Groundwater Application Review Summary Form

Application # G- 18754

GW Reviewer Darrick E. Boschmann Date Review Completed: 03/09/2023

TO: Water Rights Section Date 03/09/2023
 FROM: Groundwater Section Darrick E. Boschmann
 Reviewer's Name
 SUBJECT: Application G- 18754 Supersedes review of 12/28/2018
 Date of Review(s)

Well Location Map

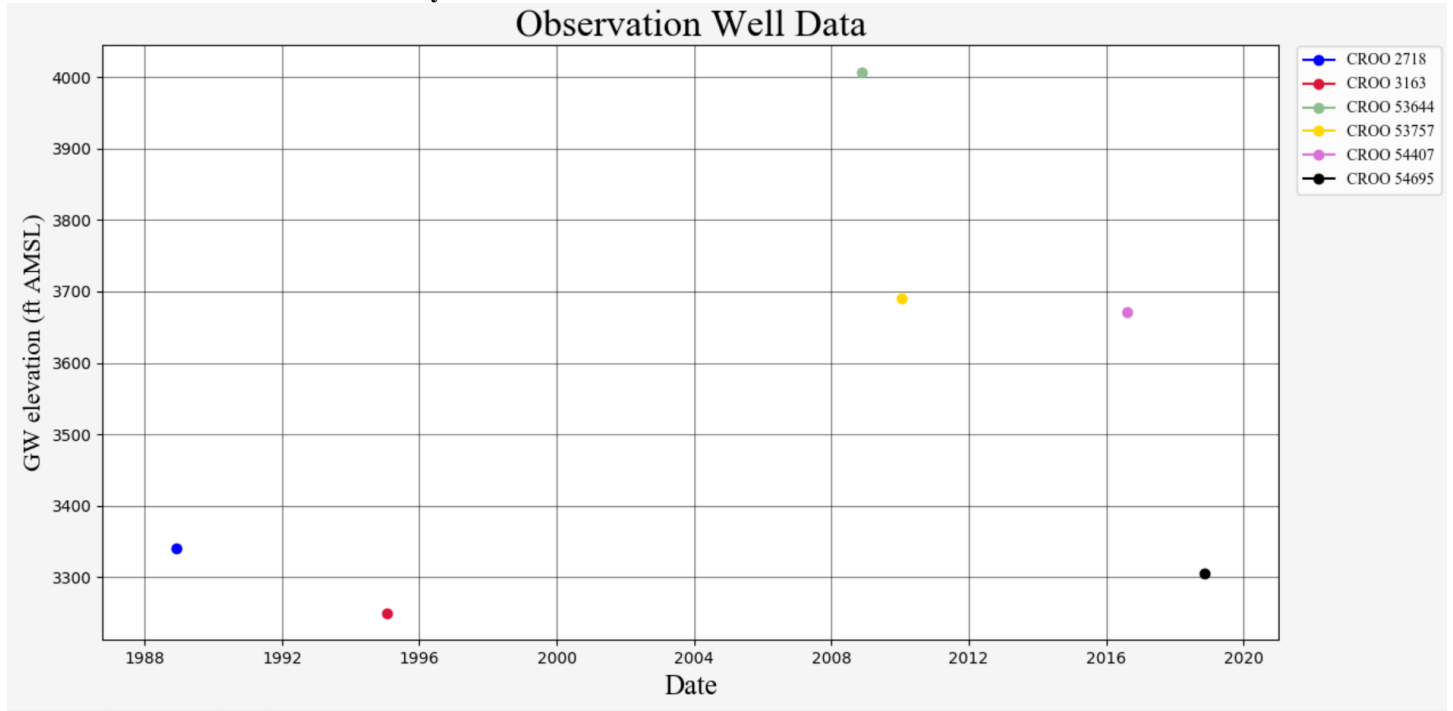
The proposed wells are located in west-central Crook County, about 6 miles northwest of Post, along the Crooked River just above Prineville Reservoir. The area underlying the proposed wells was mapped by Waters and Vaughan (1968) as Tc (Clarno Formation – lava flows, mudflows, and tuffs, chiefly of basaltic and andesitic composition). Six existing well logs for wells completed in Clarno Formation in this area report a variety of claystone, sandstone, conglomerate, and basalt lithologies, which is consistent with the description of Clarno Formation in this area from Waters and Vaughan (1968).

There are six existing wells in this area developing groundwater from the Clarno Formation with total depths ranging from 100 to 630 feet. The hydraulic head in these wells ranges from 3250 to 4007 ft amsl. Test well CROO 54965, which was drilled by the applicant to a depth of 630 feet has a reported static water level elevation of 3306 feet amsl. The groundwater elevations listed above are based on CROO 54965, as this well has a similar total depth and surface elevation as the proposed wells.

The groundwater elevation is above the elevation of the Crooked River at the adjacent reach.

The preponderance of the evidence suggests groundwater at the proposed locations is hydraulically connected to the Crooked River, and that attenuation by deep casing and seal is not sufficient to overcome the criteria specified in OAR 690-009-0040.
